Jefferson City  
Planning & Zoning Commission

**Case No. P16001  
River Bluff Condominiums, LLC  
1600 Block of Hayselton Drive  
1414 W. Main Street**

**PLANNING STAFF REPORT**  
**JEFFERSON CITY PLANNING AND ZONING COMMISSION**  
**March 10, 2016**

**Jefferson City Planning & Zoning Commission Meeting  
Engineering Division Staff Report  
Thursday, March 10, 2016, 5:15pm**

# Right-of-way width variation request

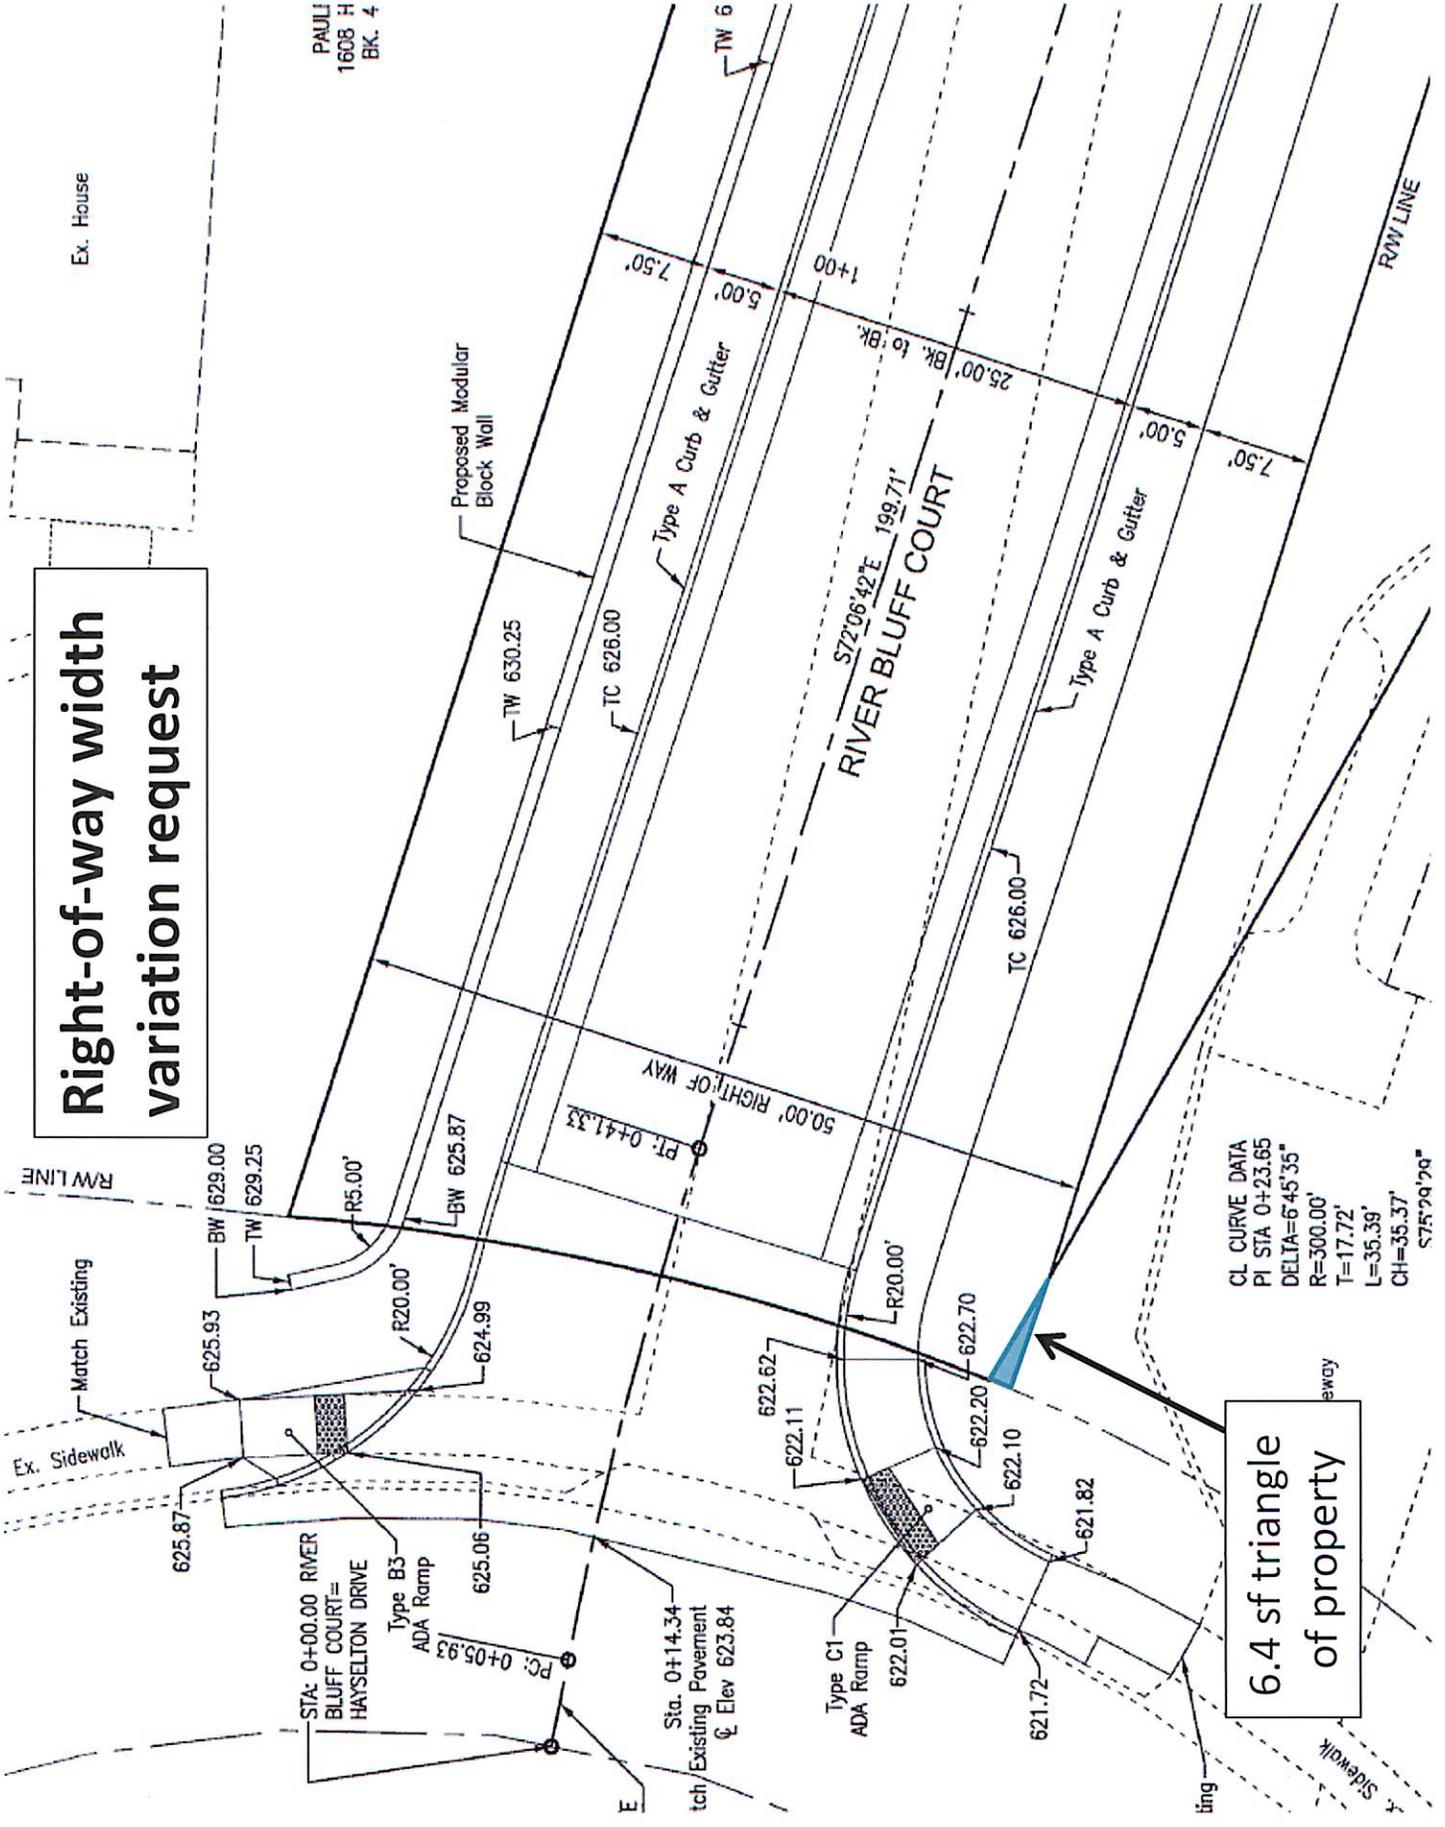
The Chinn's intended to acquire, through the above mentioned parcel division, a small 6.4 sf sliver of property in order to meet the 50 feet right-of-way width standard for residential streets prior to applying for subdivision of the property. Failure to execute that property transfer and subsequent filing of restrictions on the property results in a right of way width of 48 feet 4 inches at the Hayselton Drive street line rather than the 50 feet standard width, but widens to the standard width once beyond the small sliver of property. Please see the attached visual showing the location of the 6.4 sf property in relation to the proposed roadway and right-of-way.

Unusual circumstances surround the transfer of the small sliver of property, including litigation in Circuit Court that has lasted nearly four years. The presence or absence of the small sliver of property has no effect on the design of the street nor its relation to adjacent structures, and should not prevent a reasonable subdivision of the subject property. Staff recommends approval of the right-of-way width variation.

6.4 sf triangle  
of property

## 1600 Block of Hayselton Drive

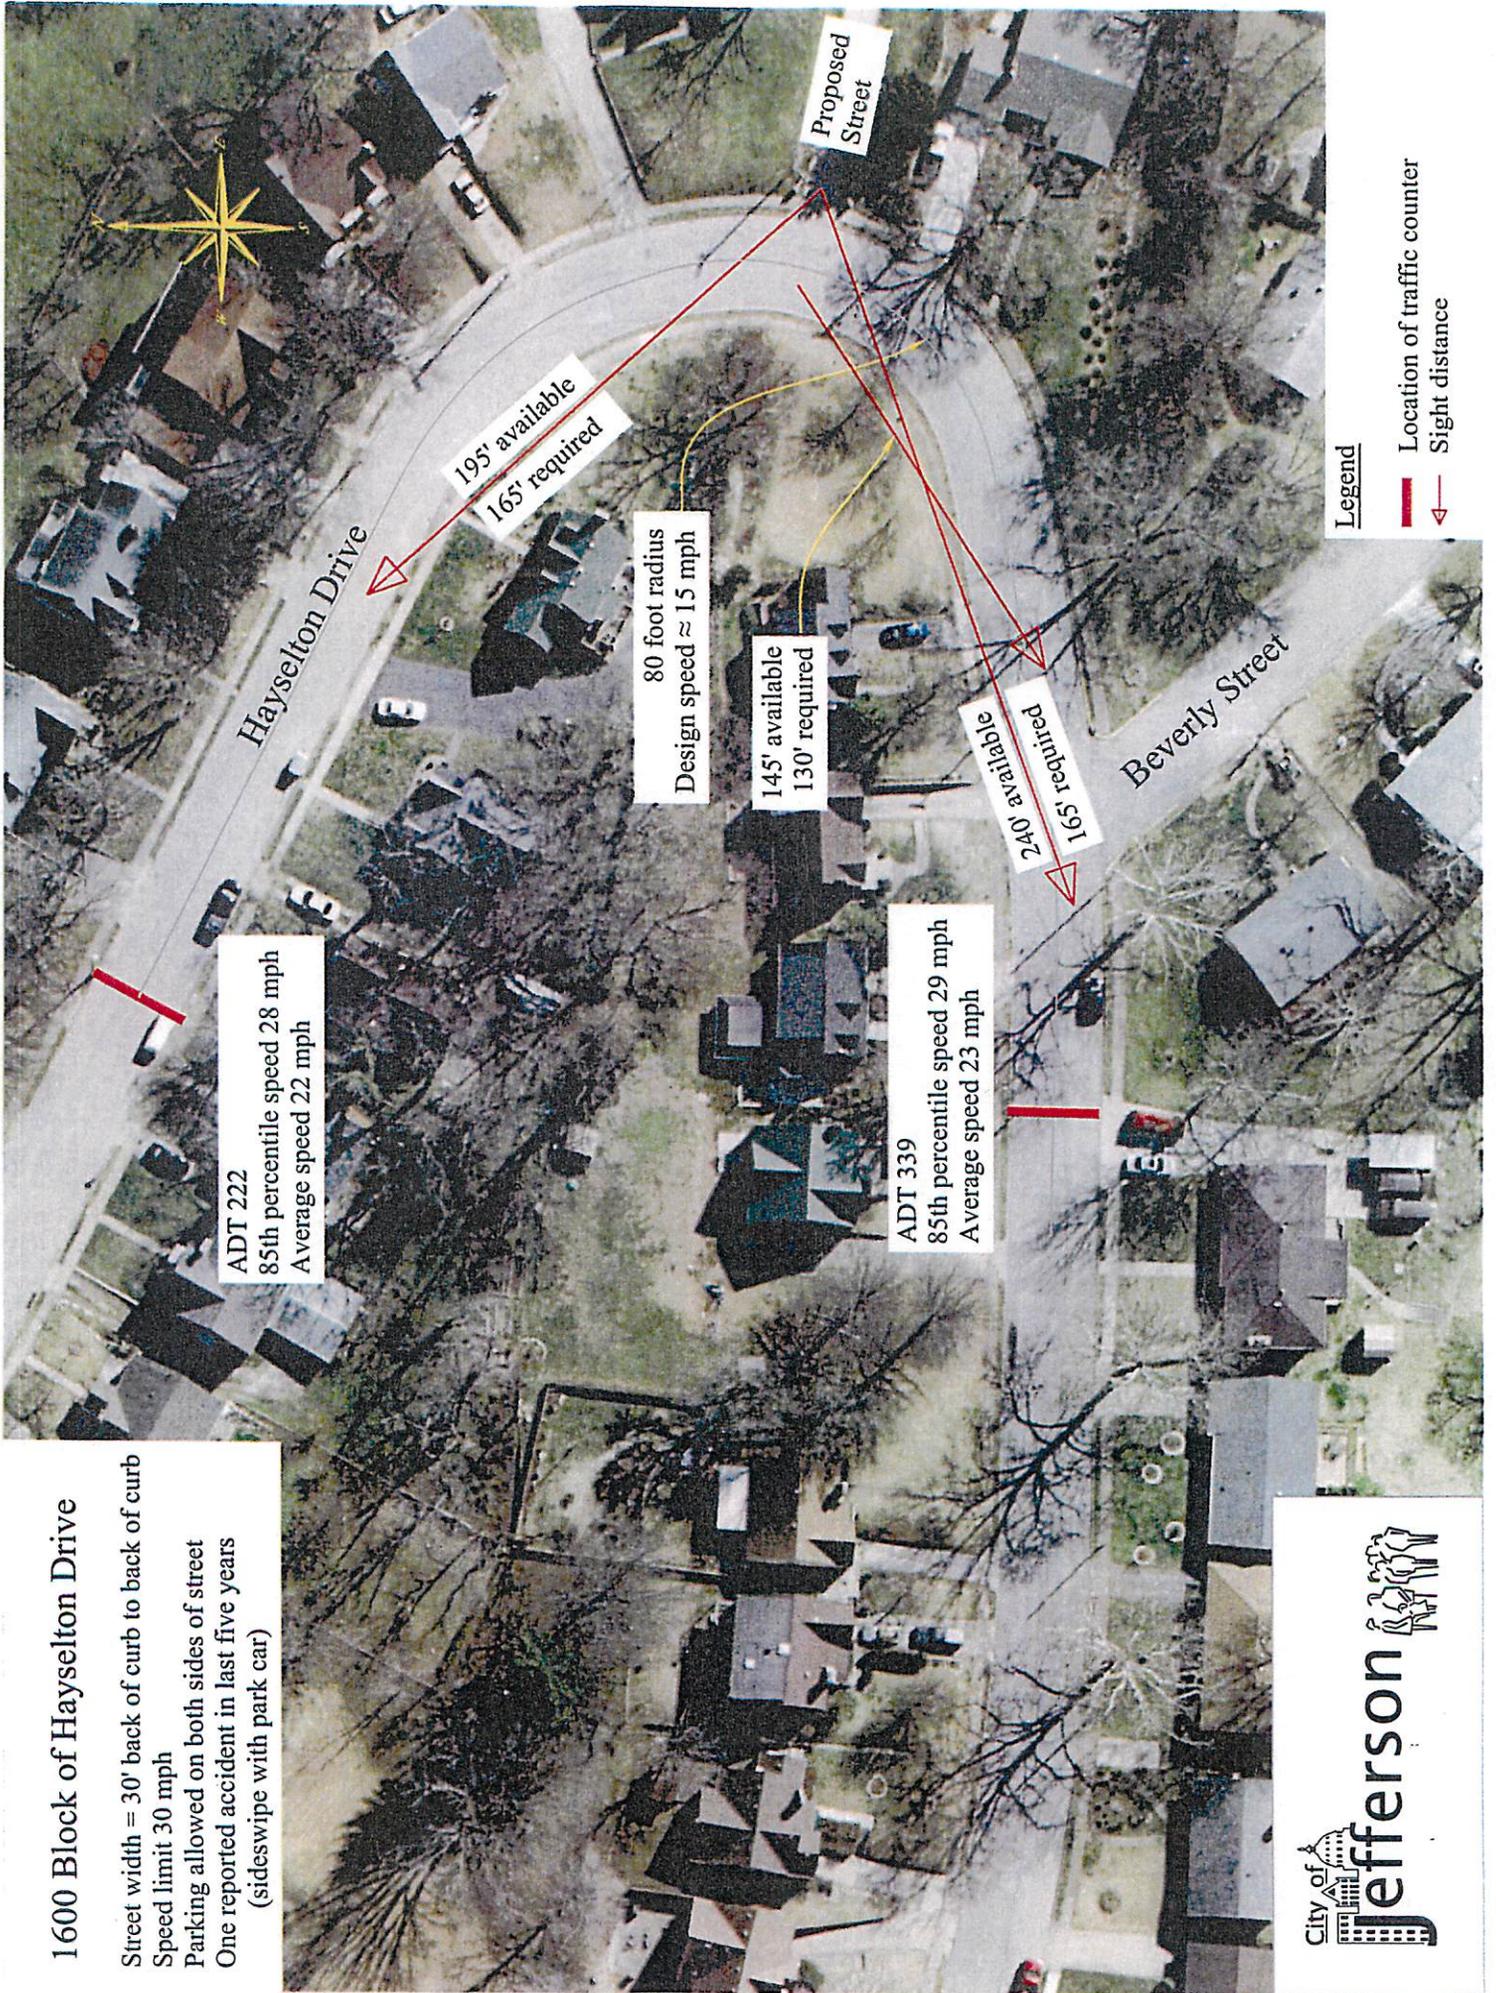
- **Speed and Volume-** The City previously performed both a traffic volume and speed count on Hayselton Drive. The results have been summarized on the attached drawing.

Locations of counters were near 1622 Hayselton Drive, northwest of the proposed development, and approximately 100' southwest of Beverly Street, southwest of the proposed development.

The 85<sup>th</sup> percentile speed ranged from 28 -29 mph during these periods at the specific locations the counters were placed.

The mean (or average) speed ranged from 22 -23 mph at the specific locations the counters were placed.

Average daily traffic volumes indicated on the attached drawing of 222 ADT northwest of the proposed development and 339 ADT southwest of Beverly Street.

Street width = 30' back of curb to back of curb  
 Speed limit 30 mph  
 Parking allowed on both sides of street  
 One reported accident in last five years  
 (sideswipe with park car)
